SECOND INTERIM REPORT
TOTAL SYSTEM PERFORMANCE ASSESSMENT
PEER REVIEW PANEL

**Peer Review of the
Total System Performance Assessment - Viability Assessment**

Second Interim Report

December 1997

Figure III-2. Location of East-West drift selected from the enhanced characterization of the repository block (ECRB) showing various options considered in the analysis.

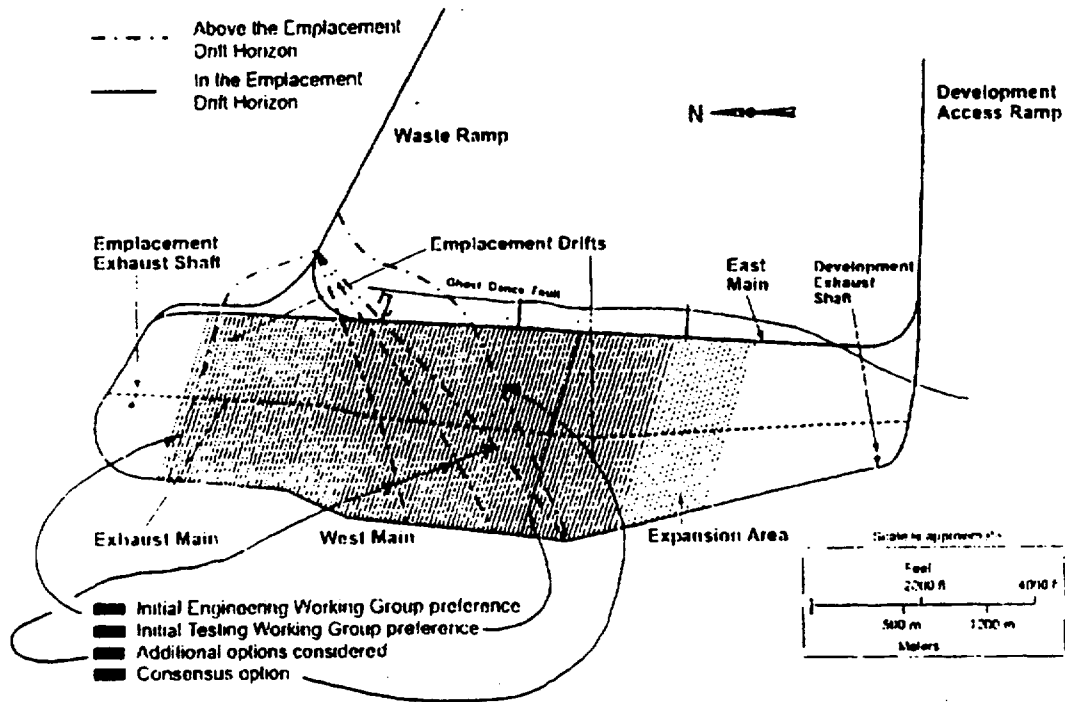
To carry out the ECRB, an integrated (DOE and M&O) team was utilized to develop a plan for an exploratory drift passing through the repository block. A consolidated list of 50 criteria was developed for a crosswalk analysis. As shown in Figure III-2., several options for the location of the cross drift were considered from which a final location was selected. There were two general perspectives that influenced the cross drift configurations: one from testing and one from design/construction. Site attributes that were of interest in testing included zones of potentially higher infiltration on the western side of the block, including evidence of fast paths. A cross section through the block

Repository exposures to the lower nonlithophysal strata generally start in the southern part of the block. The middle nonlithophysal is seen in the East Main drift (Figure III-2) and the bulk of the repository is in the lower lithophysal. During the mapping in the existing ESF, a zone of unexpected fracturing was encountered at station 43+00. A testing perspective was that predictive modeling could be done and compared to conditions encountered in this area. Also, in the southern part of the block, the Solitario Canyon fault has a reasonable amount of displacement, and the splay on the Solitario Canyon is clearly present. A recommendation for testing was to conduct drifting along the repository alignment within the repository block near station 43+00.

The design perspective was more focused on the northern part of the ECRB, which is the preferred zone for potential expansion. The design team was concerned about an excavation in the repository horizon, because if the cross drift orientation is not coincident with the eventual repository alignment, there is a potential to lose repository area. The current planned repository horizon is about as high in the section as it can go. One argument about the presence of drifting below the repository horizon was that it could constrain the ability to move the repository horizon downward. Accordingly, the design group recommended developing a drift above the repository horizon that could also be used as a performance confirmation drift. The design and testing groups reached the consensus location shown on Figure III-2.

Figure III-4. Crevice corrosion in metals (from J.R. Scully, U.S. Nuclear Waste Technical Review Board Meeting, October 23, 1997).

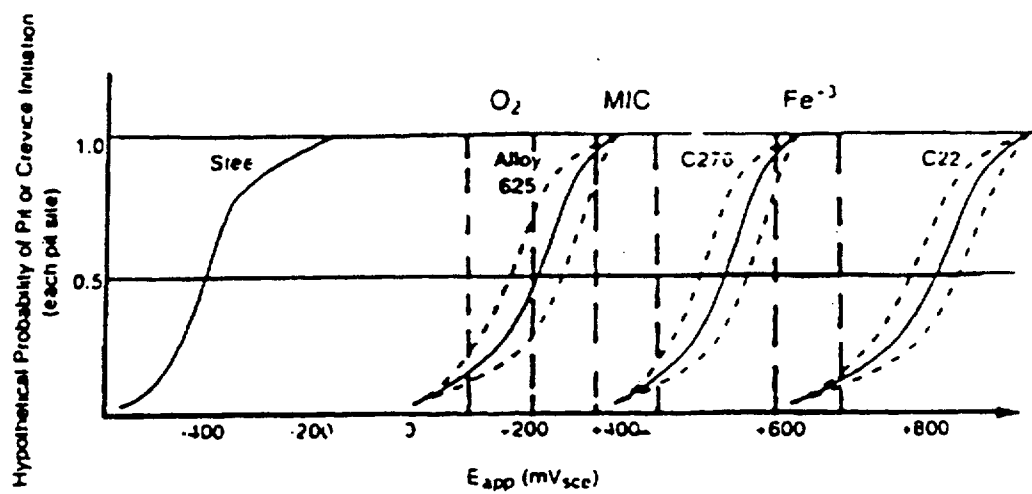
The current status can be summarized by a notional figure presented in material prepared for the Waste Package Expert Elicitation Panel and presented at the NWTRB Meeting Oct. 23, 1997. This figure (see Figure III-4) below) presents the relative resistance to crevice corrosion for steel, Alloy 625, Alloy C-276, and Alloy C-22. The last three are nickel-chromium-molybdenum alloys with increasing corrosion resistance in the order presented. For purposes of presentation, the notional crevice corrosion resistance is plotted versus the corrosive environment. On the lower horizontal axis, increasing oxidizing power of the environment is shown as more positive electrochemical potential. The upper horizontal axis shows the notional positions of an oxygen containing environment (O_2), an environment with active microbial activity, and a highly oxidizing environment containing ferric ions (Fe^{+3}). The S-curves show the boundary between no corrosion (to the left) and the initiation of crevice corrosion (to the right). The dashed lines are the notional representation of uncertainty for corrosion behavior. Data generated by experiments are required to support materials selection and assessment of realistic performance.
